Addendum No. 4

Date: April 15, 2013
To: Contractors
From: Matthias Mueller – Program Director
Reference: Bachelor Enlisted Quarters Facility
Utah National Guard – Camp Williams, Utah
DFCM Project No. 10281480

ADDENDUM FOUR

BACHELORS ENLISTED QUARTERS FACILITY

A2 PRECAST CONCRETE PLANTER CAP
 1 1/2" = 1'-0"

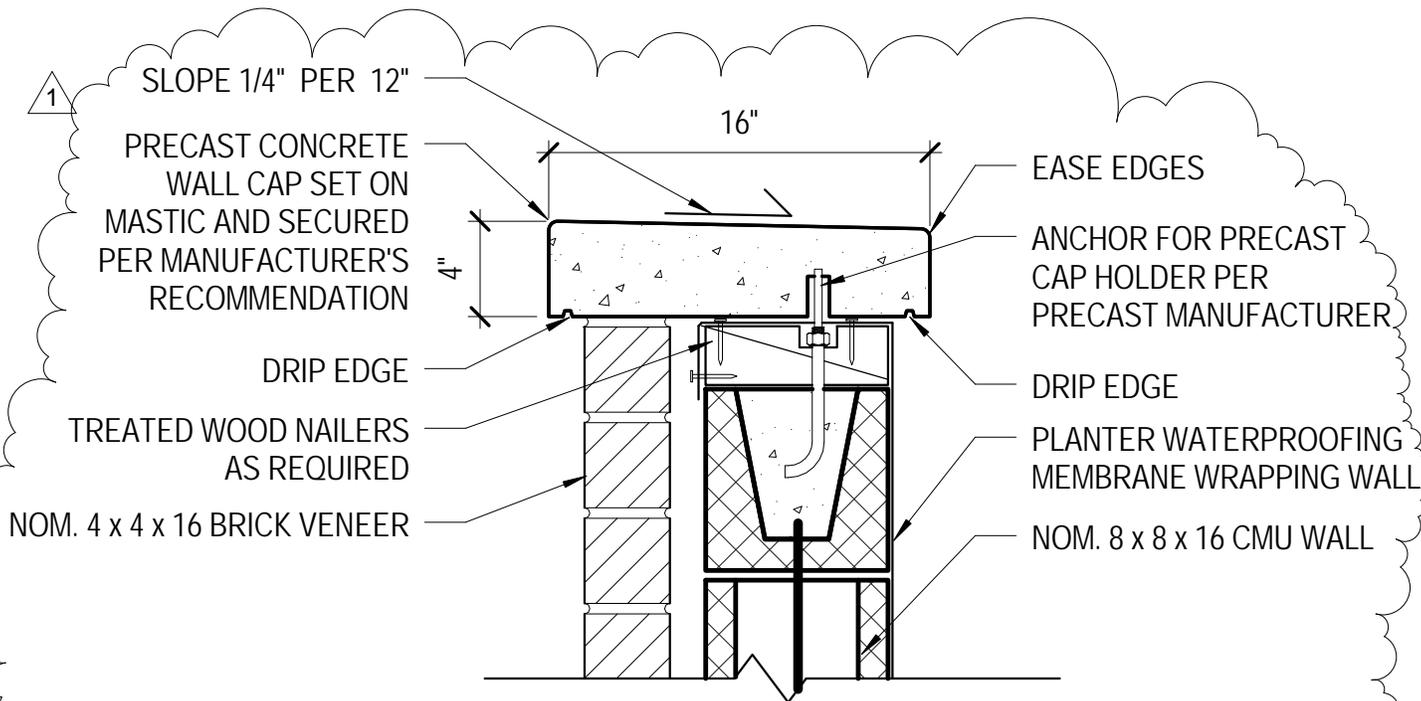
- Modified precast engaged column floor plan.
 - Added notes to precast engaged column floor plan.
- 4.A09 Add detail A2 to sheet A519M per the attached AD4-A03 drawing.

E3 ADD04-A04
 1 1/2" = 1'-0"

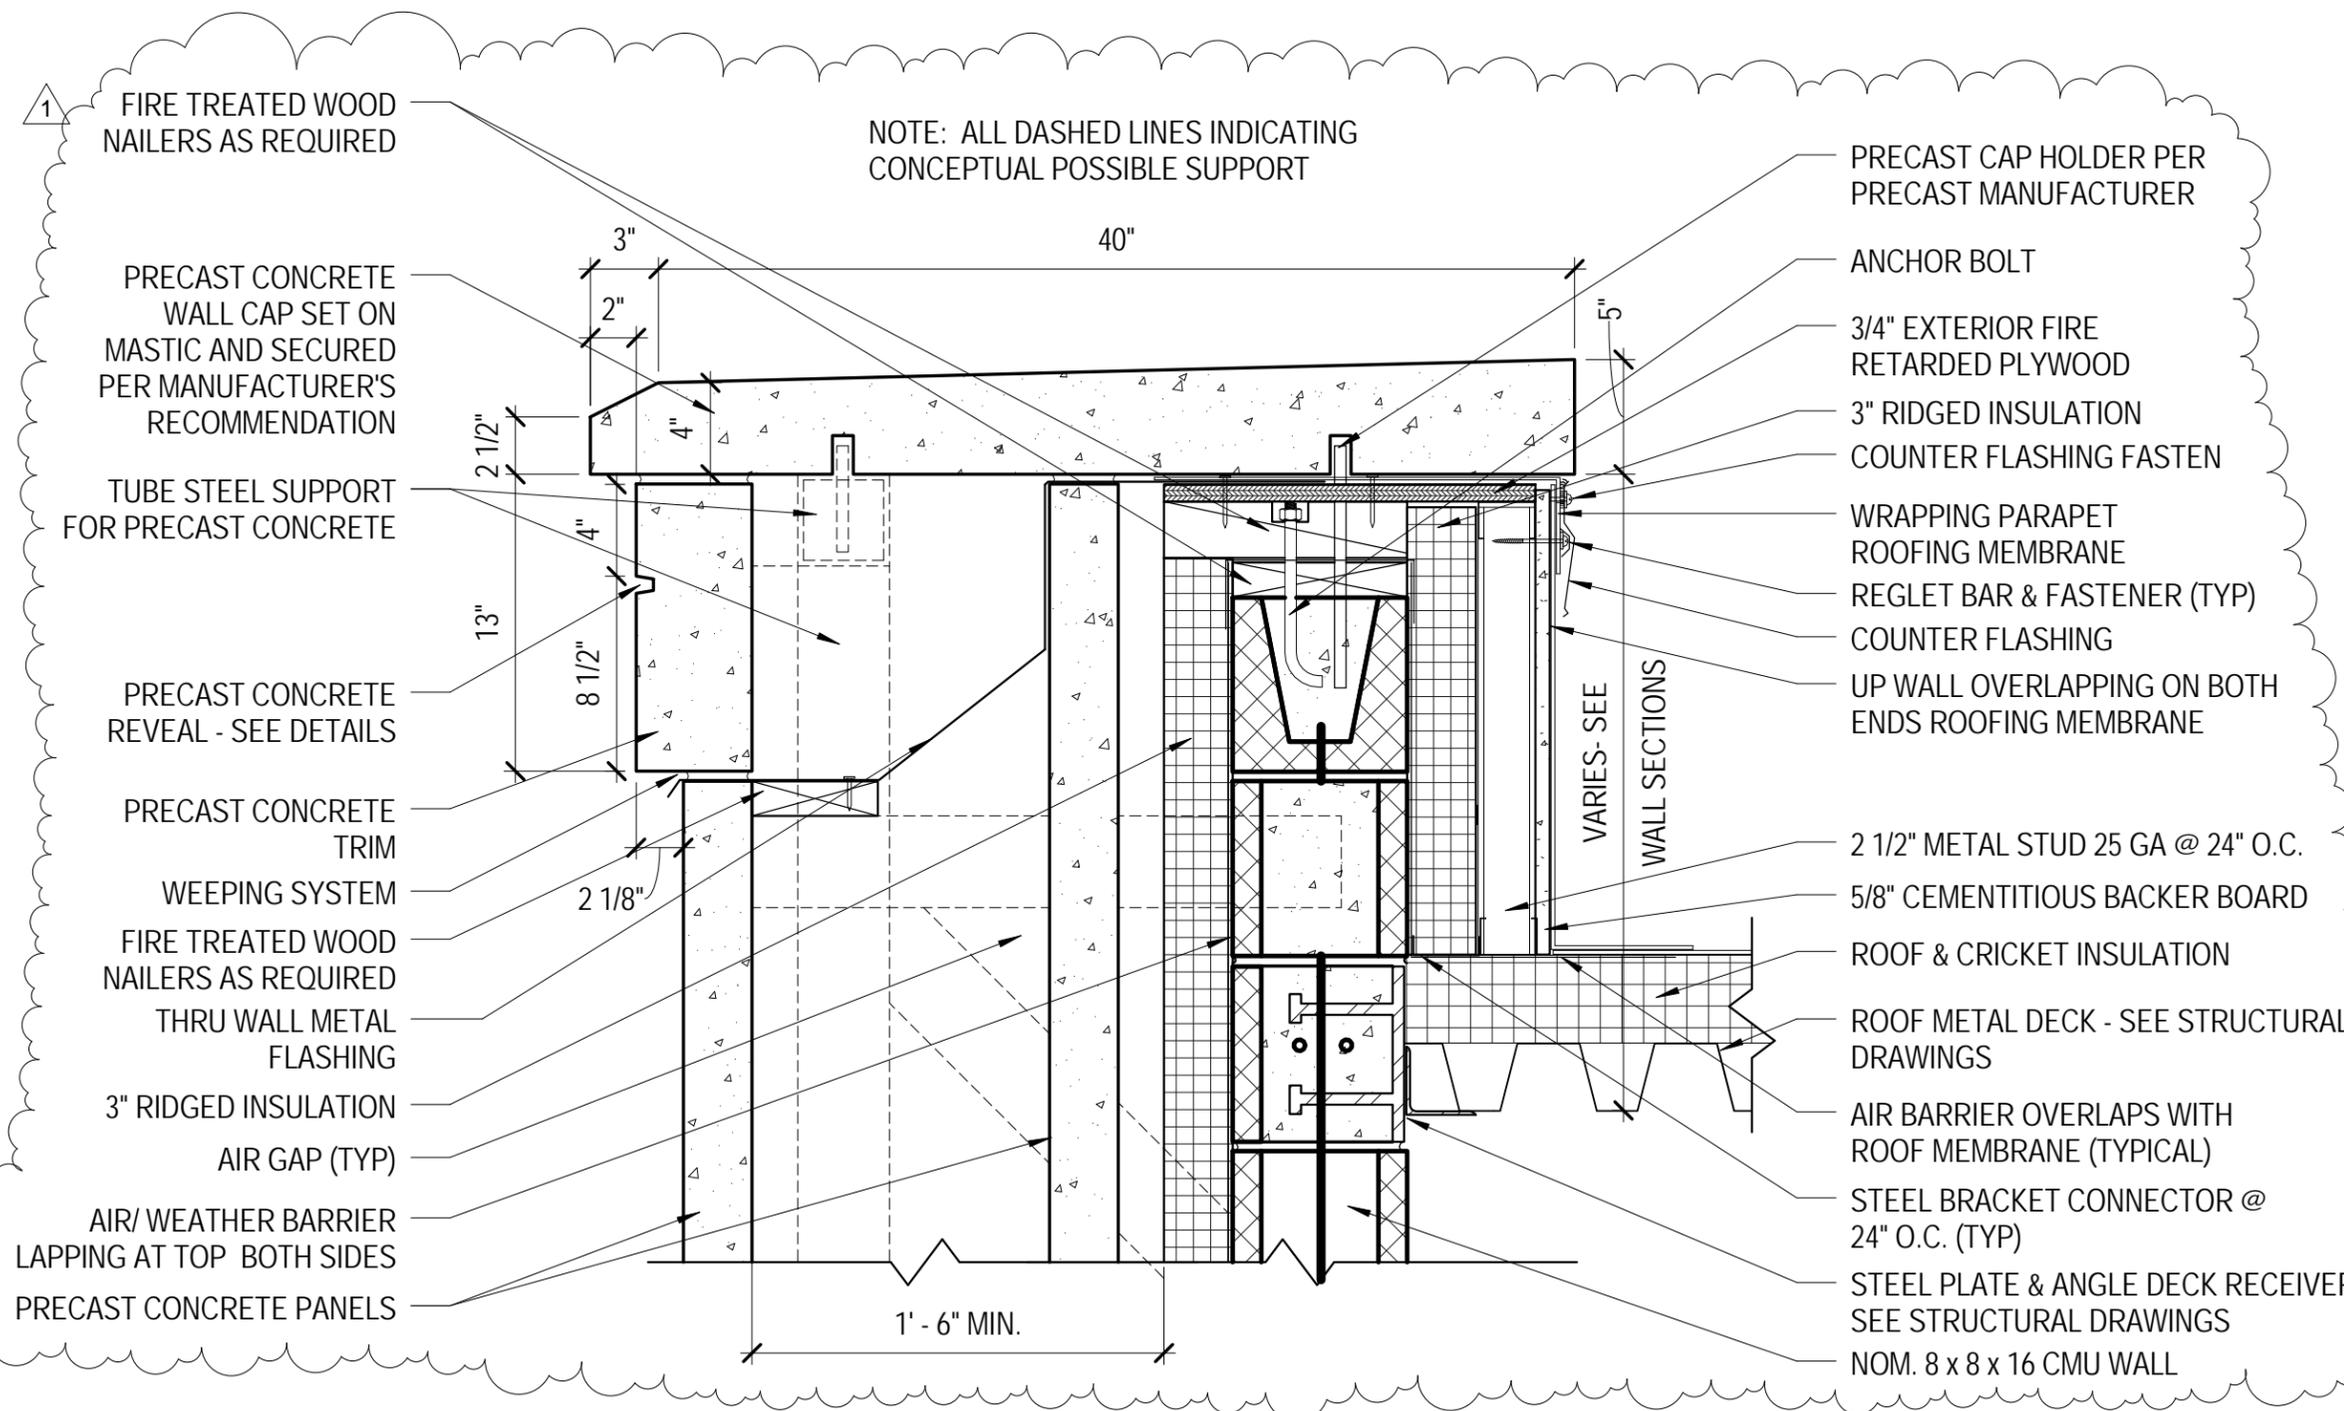
- 4.A12 Replace detail E3/A521 with the enclosed updated detail AD4-A04 drawing.
- 4.A13 Detail E4/A522: On left side of parapet wall replace description of arrow
leader pointing to continuous roof insulation to read: ROOF & CRICKET
INSULATION.

DRAWN BY: **WRT** CHECKED BY: **DLA**
 PROJECT NO: **11007** DRAWING NO: **EL101A**
 DATE: **02/15/2013**

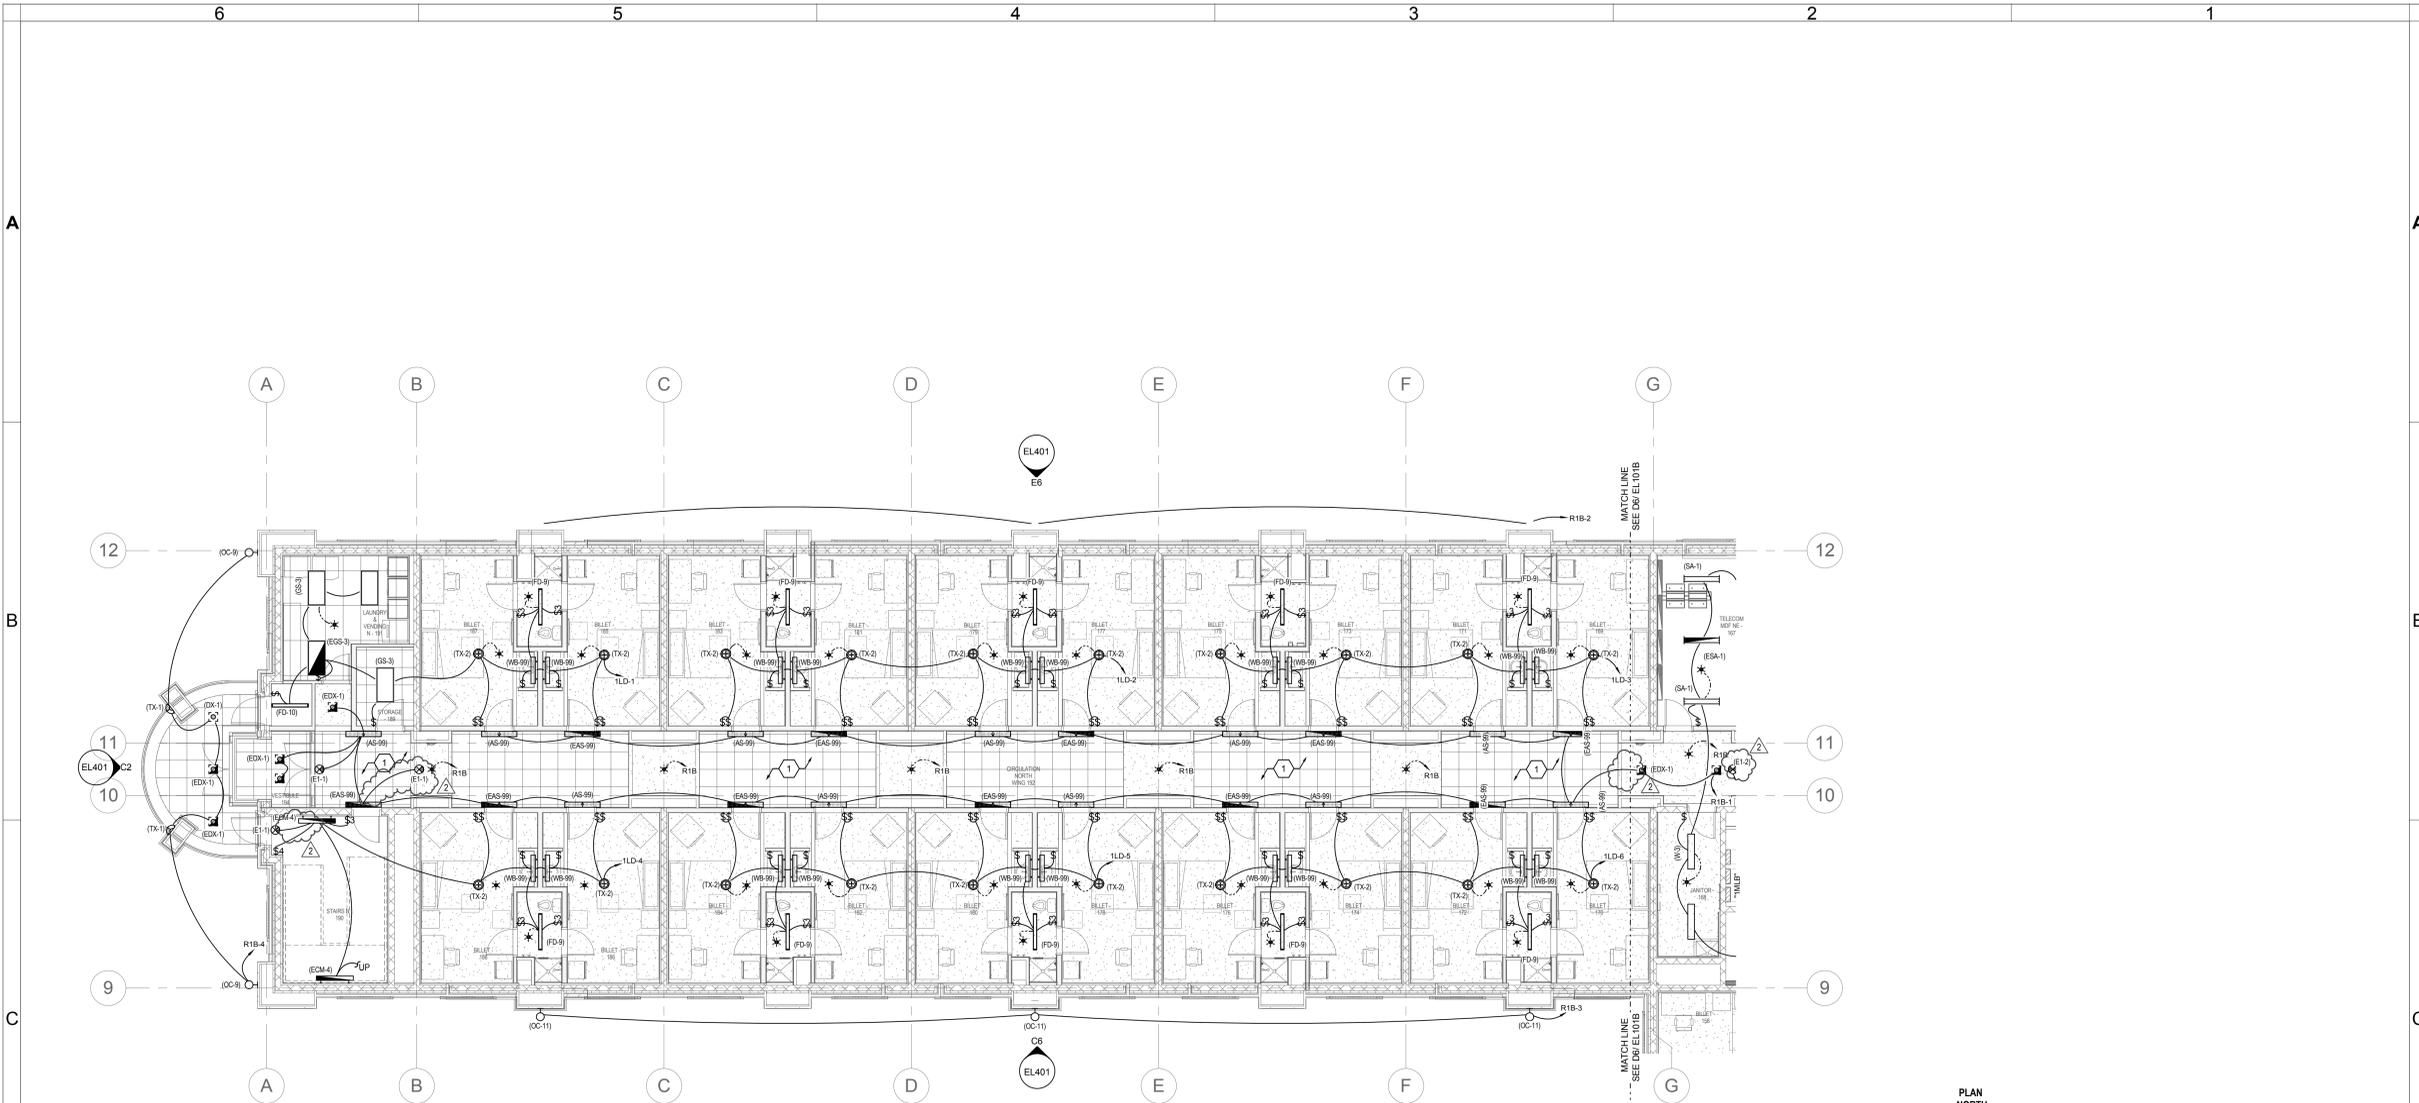
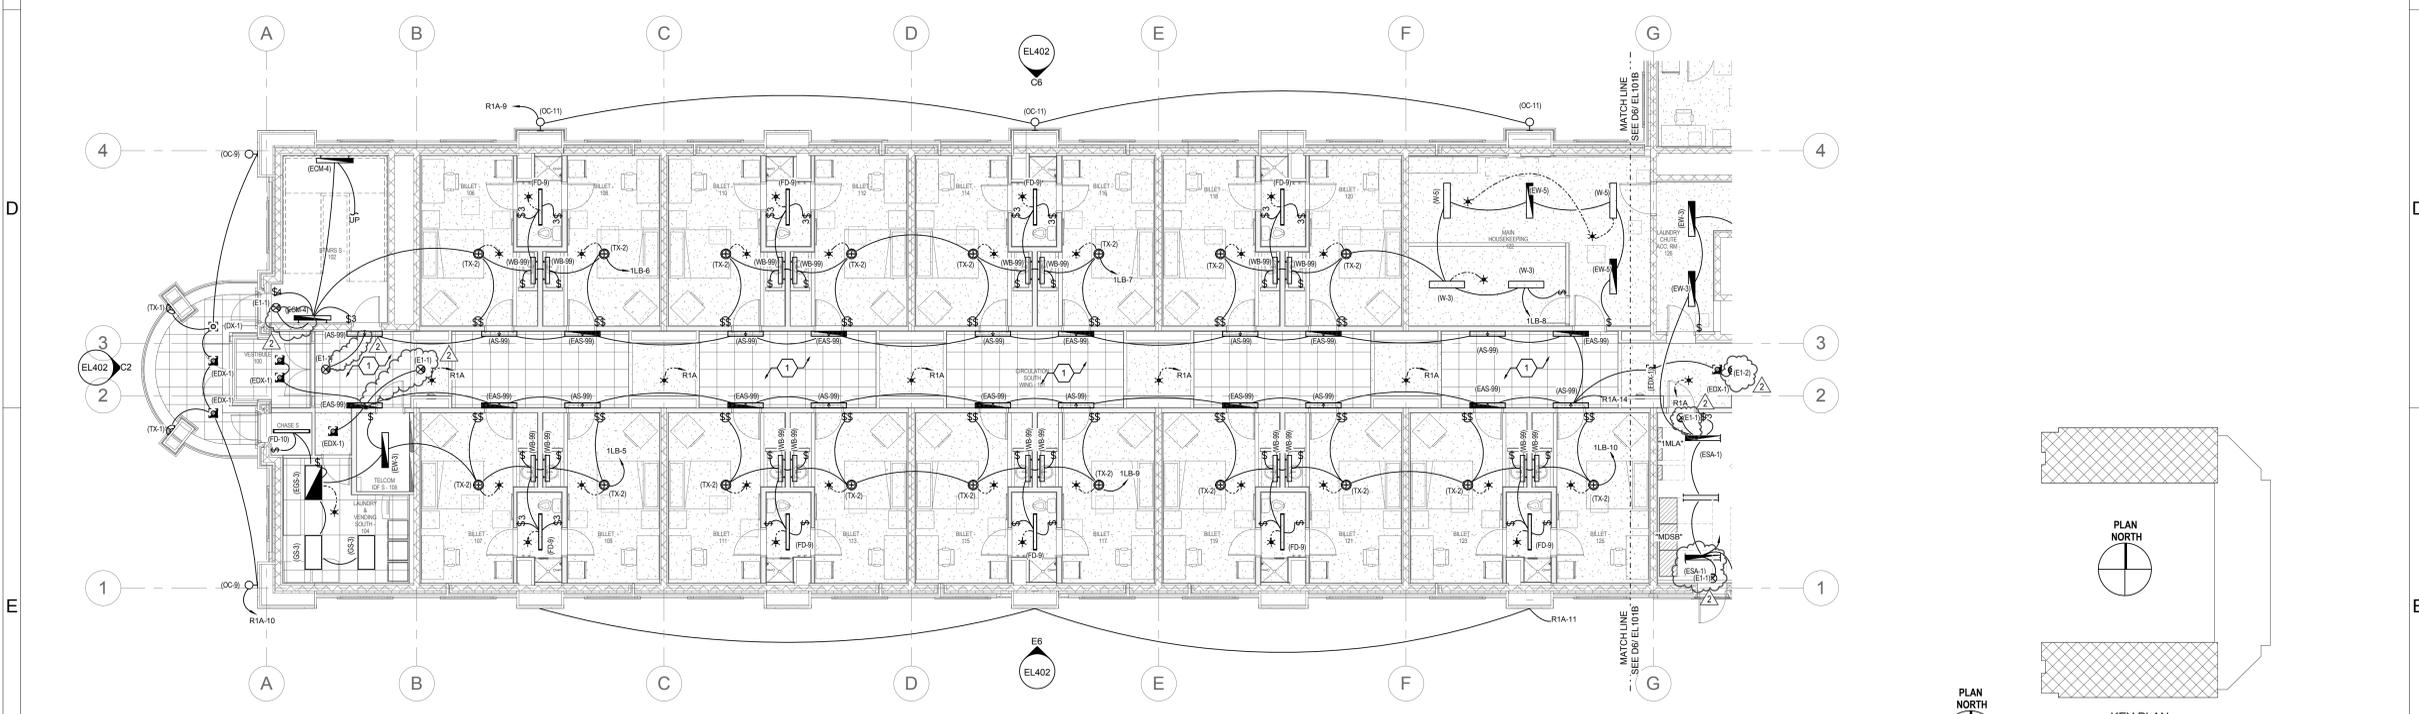
- a. Added power connections for (2) exit signs near Vestibule 100.
- b. Added (1) exit sign on the lower ceiling to the east of Vestibule 100 for increased visibility.
- c. Added power connection for (1) exit sign in Stair 190.
- d. Added (1) exit sign on the lower ceiling to the east of Vestibule 194 for increased visibility.
